COUGAR CREEK DEBRIS FLOOD RETENTION STRUCTURE

Project Update

ADDENDUM

SUBMITTED BY:
Town of Canmore

| Figure 1 | Footprint Comparison - Overview |

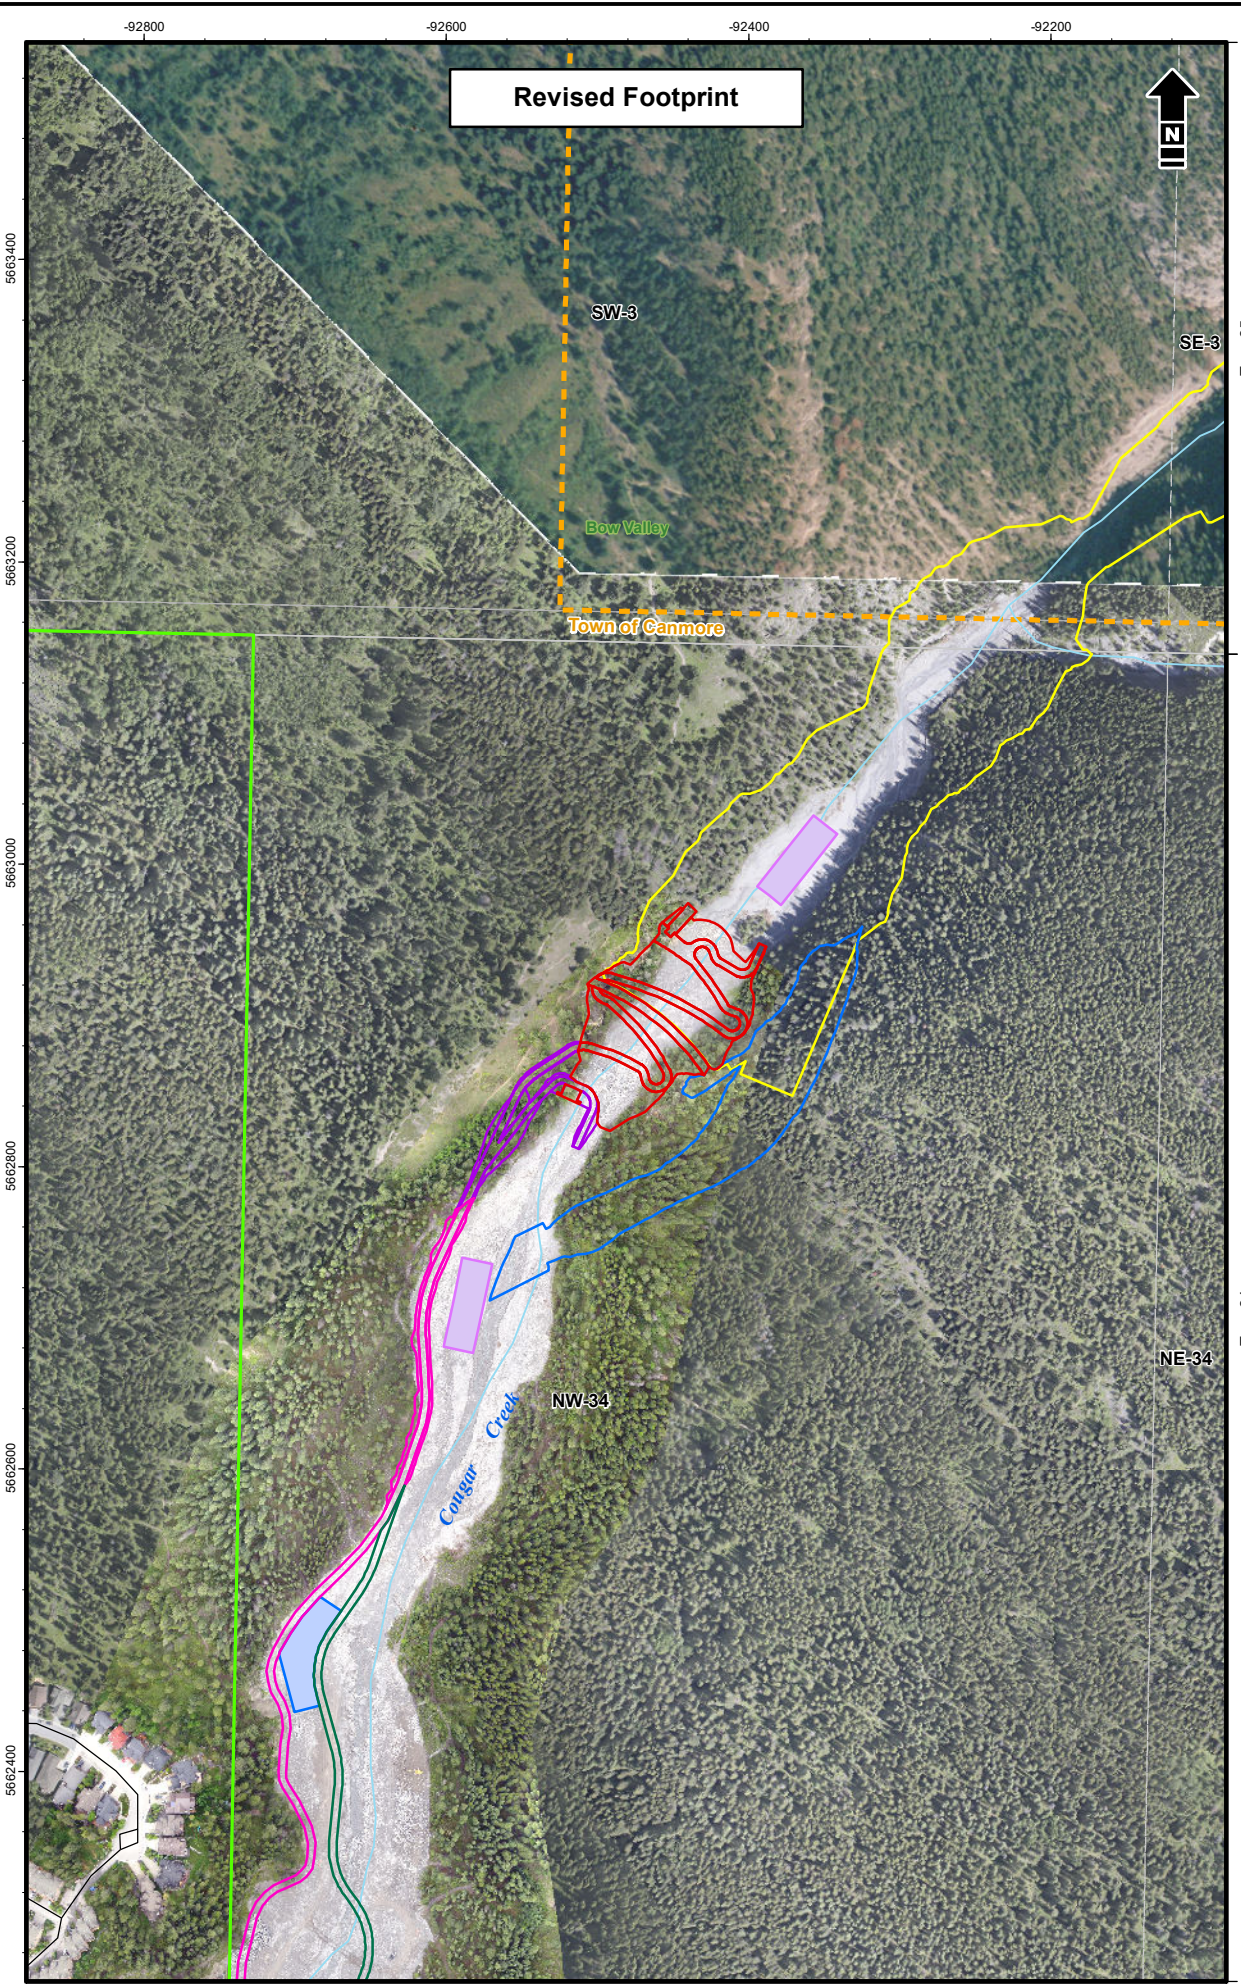
The basic design, function, and location of the Structure has not changed; but some of the design elements, particularly the approach to spillway design and flow control, have been optimized. Figure 1 compares the footprint of both the original and revised design. Figure 2 presents a plan view of the revised Structure and spillway design.

As discussed in Section 2.2, removing the spillway from the Structure allows for the majority of the access road to be located on the downstream face of the Structure rather than in the designated wildlife corridor to the west (Figure 1).

STRUCTURE AND SPILLWAY PLAN VIEW

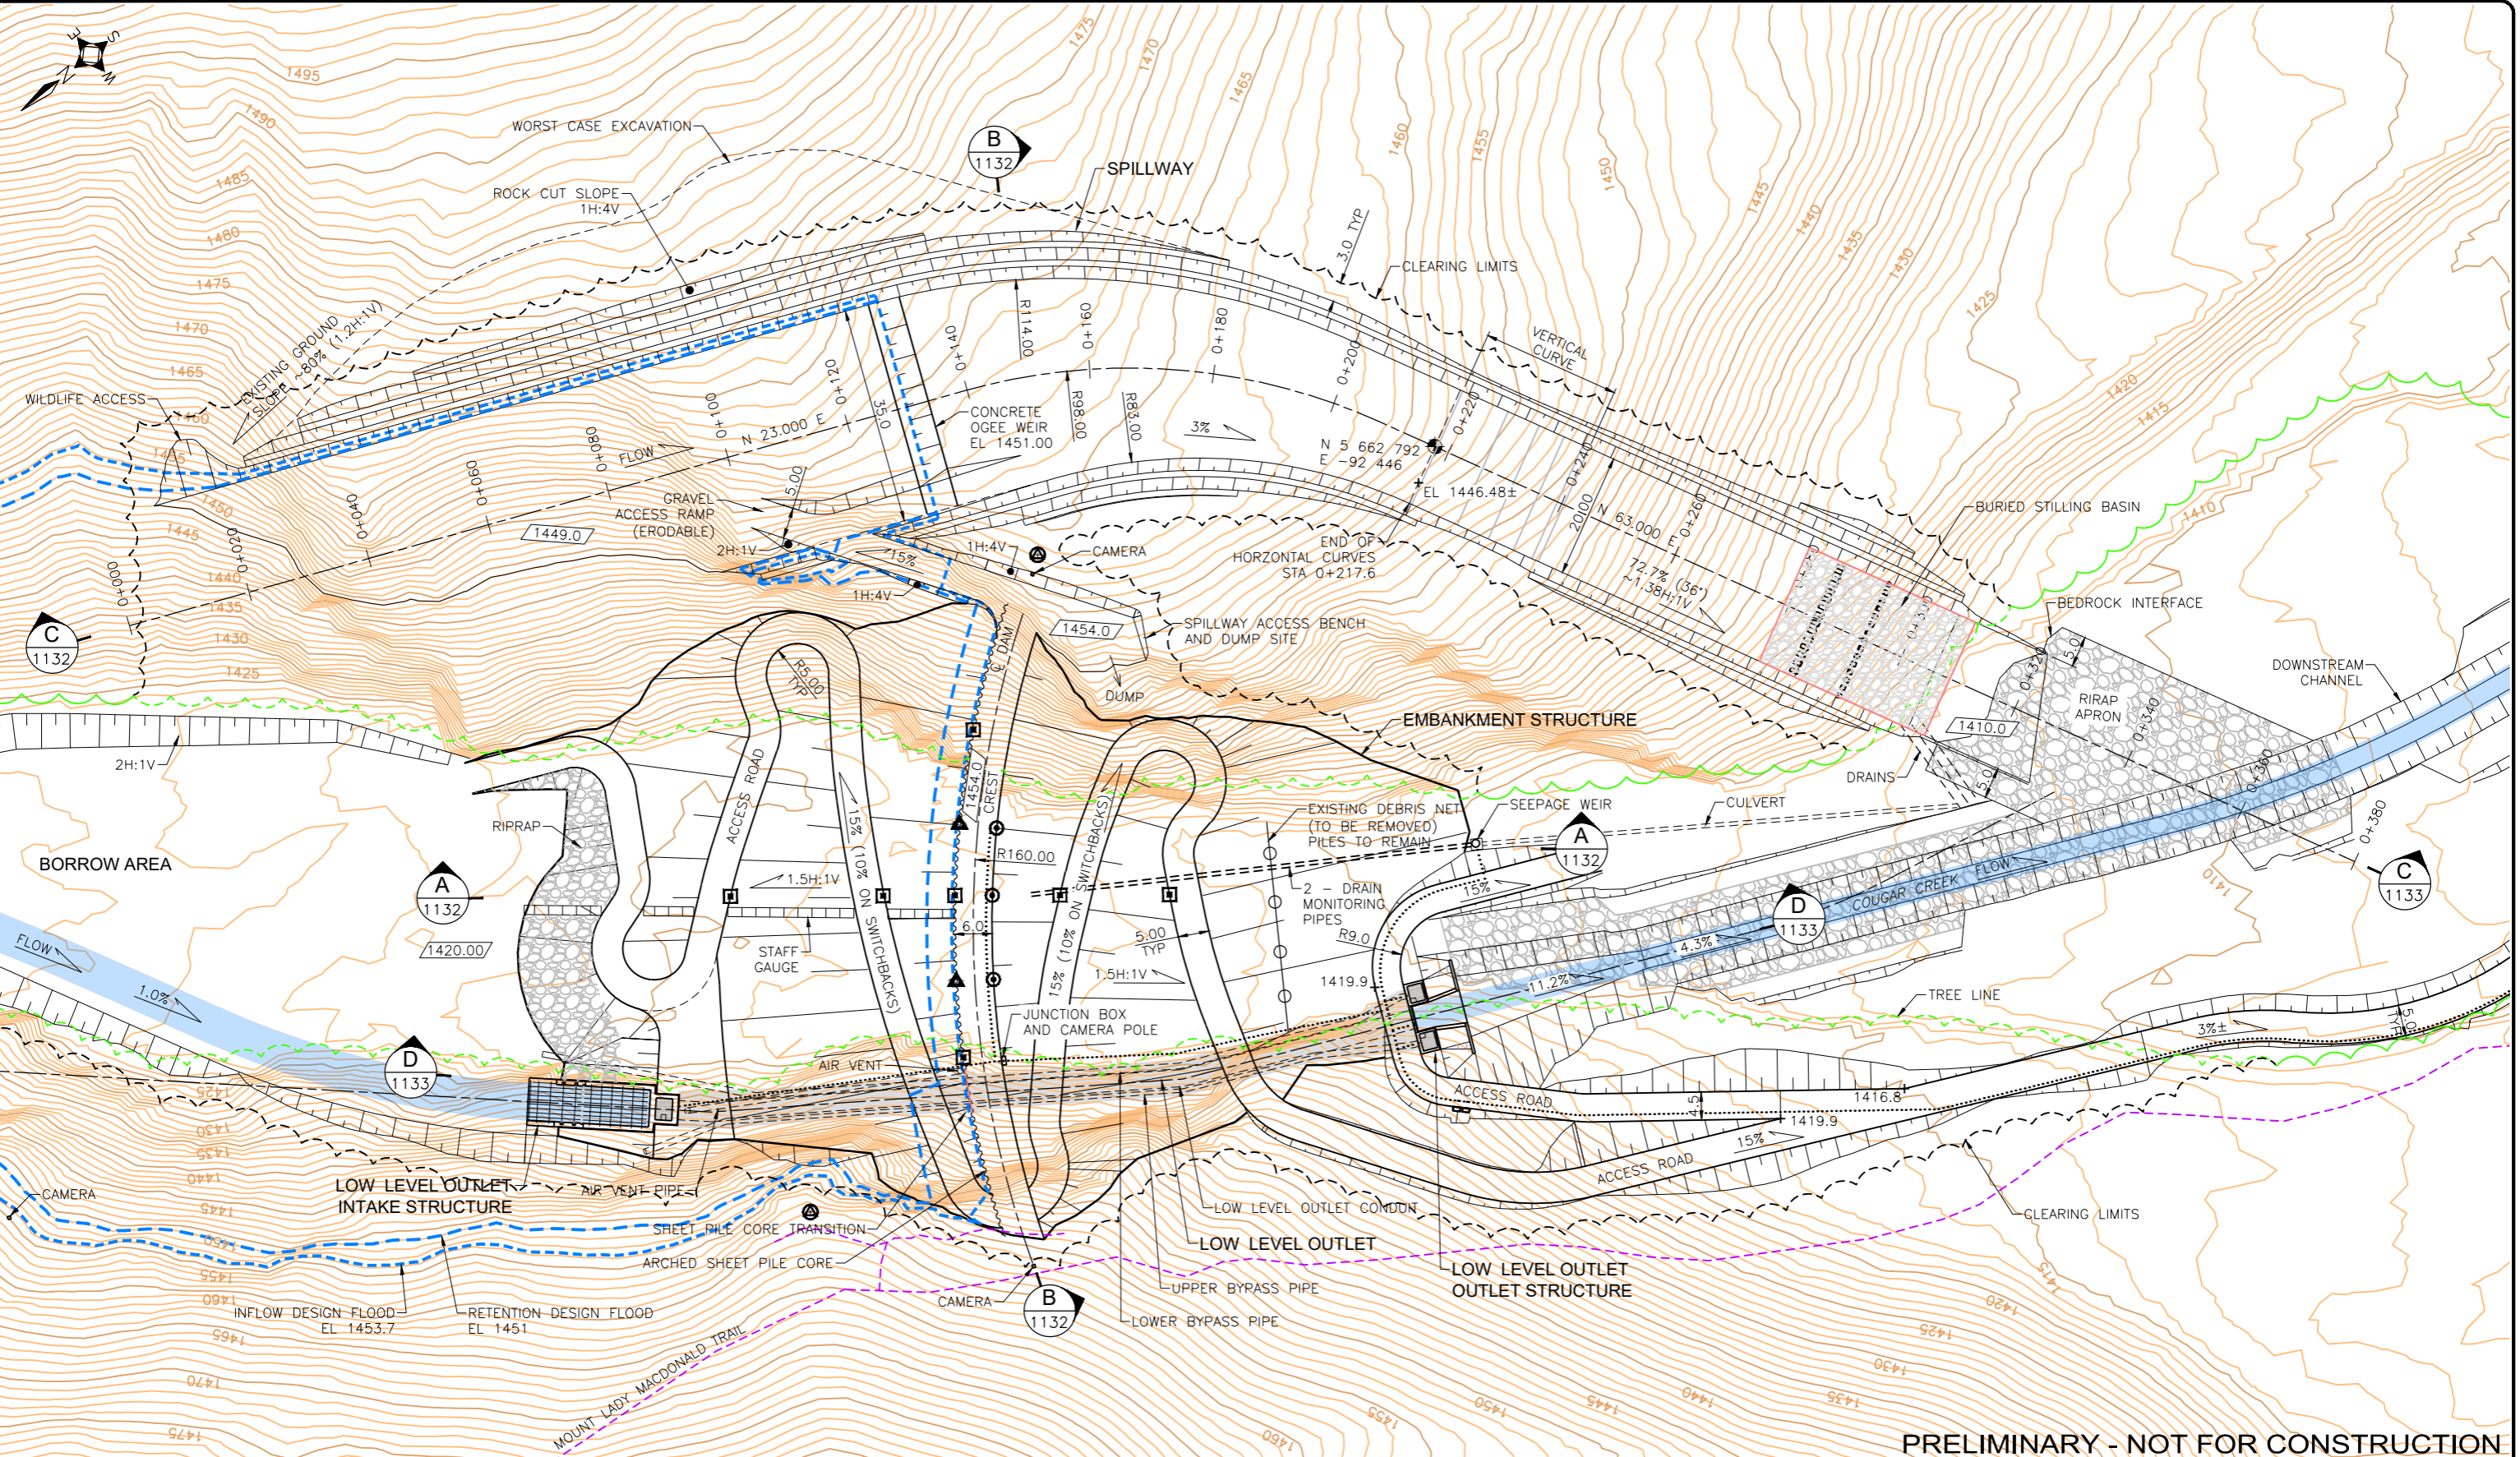
1. **Flow Control (Low Level Outlet):** The original design included a diversion tunnel and associated emergency bypass pipes through the east abutment. The revised design includes a concrete encased large diameter steel conduit and associated emergency bypass pipes built into the embankment of the Structure at creek level on a rock bench at the west abutment. There is no functional change between these two design options as they provide the same outflow rate, and the general design of the inlet and outlet structures has been retained. Minor modifications of the inlet and outlet structures were required to ensure compatibility with the new configuration.

2. **Spillway:** The original design incorporated a concrete spillway on the downstream face of the Structure. The revised design includes a rock-cut spillway located on the east abutment. The excavation of the rock-cut spillway provides rock for the embankment fill. The rock-cut spillway eliminates the need to accommodate flood waters over the crest of the Structure, resulting in reduced design complexity, reduced Project-related traffic to haul fill materials, and reduced construction costs. There is no functional change between these two design options as they both provide the same capacity and are designed to the same standard (Section 2.4).

The revised low level outlet (LLO) design includes a 3.1 m diameter concrete encased steel conduit and two 36-inch (0.91 m) diameter emergency bypass pipes, located at creek level on a rock-cut bench on the west abutment (Figure 2).

The original design incorporated a spillway on the downstream face of the Structure that is replaced by a rock-cut spillway located on the east abutment (Figure 2). The rock-cut spillway is deeply incised into bedrock. It is approximately 250 m long, 35 m wide at the weir crest, 20 m wide at the chute, with a maximum depth of 30 m at the Structure crest. The steep internal spillway walls are terraced in 8 m high steps. The rock-cut spillway and stilling basin are designed with the same performance requirements as the original design. The chute slope angle, of approximately 36 degrees, follows the natural bedding plane of the bedrock in the spillway location. The revised design uses the same IDF for design; has the same weir crest elevation; and has a similar chute, stilling basin design and predicted inundation area.
